AMENDMENT OF SOLICITATION / MODIFICATION OF CONTRACT			1. Contract Number DCKA-2014-B-0083	Page of Pages 1 22
2. Amendment/Modification Number Amd 5	3. Effective Date See 16C	4. Requisition/Purchase Request No.	5. Solicitation Caption 27th Street Bridge

14. Description of Amendment/Modification (Organized by UCF Section headings, including solicitation/contract subject matter where feasible.)				
Solicitation No.: DCKA-2014-B-0083- 27th Street Bridge over Broad Branch Stream adjacent to Rock Creek Park

1) Revised bid tab- attachment #1 2) Responses per contractor inquiries- attachment #2 3) Amended Special Provisions- attachment #3 4) Quantity summaries and revised plans sheet S-4 and S-5- attachment #4				
This solicitation is further amended to reflect the number of trainees

Response to RFI for 27th Street Over Broad Branch Stream Pre-Bid Contractor Comments

ABUTMENT A - PLAN AND ELEVATION

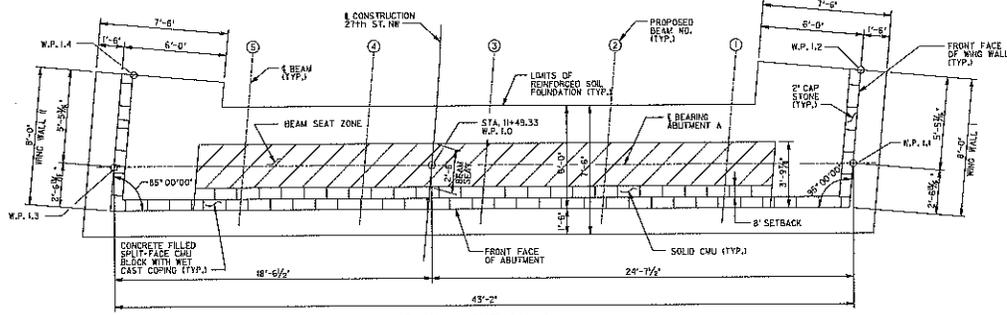
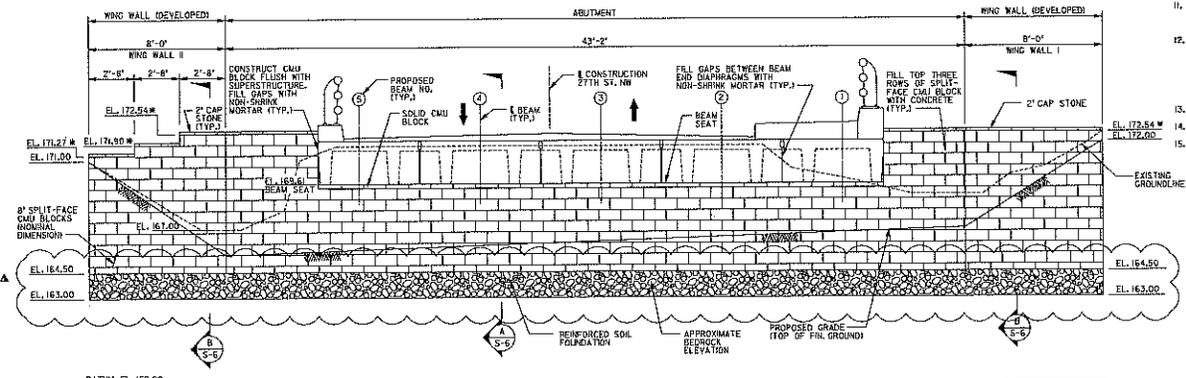
22	Special Provisions	C018.B-d.	Is the General Contractor responsible to perform additional testing of the Split Face Hollow Concrete Masonry Unit outside of that provided by the manufacturer?	Yes, testing shall be in accordance with ASTM C140-12.
S-4 of 18	Drawings Special Provisions	Elevation - Abutment A C018 C-6	Special provisions state that the first course of the wall facing shall be set level to grade. A thin leveling layer of fine aggregate up to 0.5 inches to level the first course. The detail shown for the abutments is greater than 0.5 inches. Please provide a detail as to how the leveling course shall be provided above the RSF.	Dwgs S-4 and S-5 have been modified
S-6 of 18	Drawings	Section A-A	The GRS-IBS calls for the top 3 rows of the CMU structure to have a concrete fill with reinforcing. Please provide a detail for this section.	Geotextile reinforcement may be cut to allow for reinforcement and concrete placement provided 85% of the CMU top surface is covered throughout each abutment.
